From: Wight, Brian [mailto:brian.wight@aecom.com]
Sent: Thursday, May 10, 2018 8:18 AM
To: KNIGHT, COLE D GS-12 USAF HAF 22 CES/AFCEC/CZOM <cole.knight@us.af.mil>
Cc: Mark D. Wichman (mark.d.wichman@usace.army.mil) <mark.d.wichman@usace.army.mil>; Sansom, Andrea NWO <Andrea.Sansom@usace.army.mil>; michael.d@ageiss-inc.com; HURTADO, JOSE J CIV USAF AFMC AFCEC/CZRX <jose.hurtado@us.af.mil>; GUTIERREZ, NEYDA V CTR USAF AFMC AFCEC/CZRX <neyda.gutierrez.1.ctr@us.af.mil>; Krause, Michael <michael.krause@aecom.com>; Mowan, Ryan <ryan.mowan@aecom.com>; Gangelhoff, Dustin <dustin.gangelhoff@aecom.com>
Subject: [Non-DoD Source] FW: McConnell AFB PBR: Responses to KDHE Comments on Final SS544 (SWMU107) RFI

TECHNICAL REVIEW COMMENTS
McConnell AFB PBR
W9128F-13-C-022
SS544 (SWMU 207)
Final SWMU No. 207 (SS544) RCRA Facility Investigation Report
McConnell Air Force Base, Wichita, Kansas
Date of Comments: 1 December 2017

Figure 1. Ramp 400 area showing RFI sample locations.

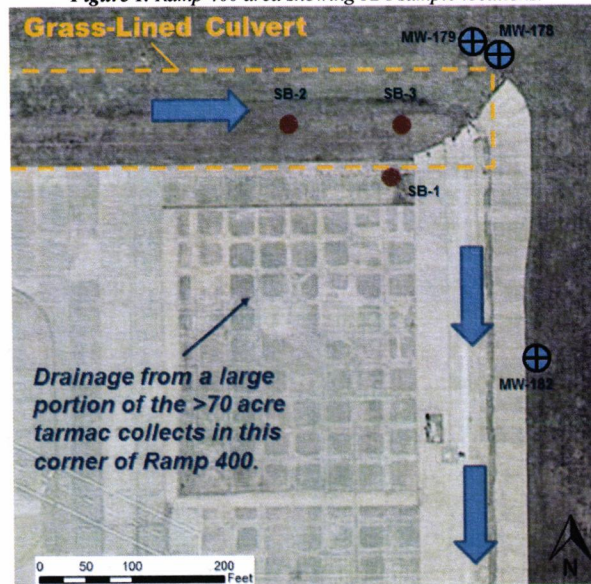
1. The identification of the Ramp 400 Area as a potential source for VOC contamination is not adequately supported by groundwater data presented in this report and the lack of detected VOCs in the soil samples collected in this area.

URS Response: At the Ramp 400 area, the suspected release mechanism of contaminants of concern (COCs) to groundwater is the infiltration of storm water (surface runoff) containing dilute concentrations of COCs from a large portion of the Former Boeing tarmac, a >70 acre area with a long history of aircraft maintenance activities. The following lines of evidence support our proposed conceptual site model (CSM) for Ramp 400:

- 1) Storm water runoff from the Former Boeing tarmac is directed north towards the grass-lined culvert and then south along the concrete-lined culvert (see **Figure 1**). Field observations during RFI sampling events confirmed pooling of water in the grass-lined culvert during/after a storm event. Surface runoff entering the grass-lined culvert has the potential to infiltrate the subsurface (and the underlying paleochannel deposits), serving as a source of COCs during historical maintenance activities on the tarmac.

- 2) The distribution of contaminant mass in groundwater in the paleochannel deposits is centered in the Ramp 400 area. Specifically, local maximum concentrations of Carbon Tetrachloride (see Figure 3-8 of the RFI report), 1,1 Dichloroethene (see Figure 3-9 of the RFI report), and Trichloroethene (see Figure 3-10 of the RFI report) were identified at monitoring well MW-178, located alongside the grass-lined culvert of the Ramp 400 area (see **Figure 1**). Elevated concentrations of these COCs were also detected at other Ramp 400 monitoring wells (MW-34, MW-179, MW-180, MW-182).

- 3) Benzene and Toluene were detected in soil samples from boring SB-3 during the RFI (see Table 3-3 of the RFI report). This is consistent with our proposed CSM for Ramp 400, where contaminated runoff consists of a mixture of various COCs infiltrated the subsurface.
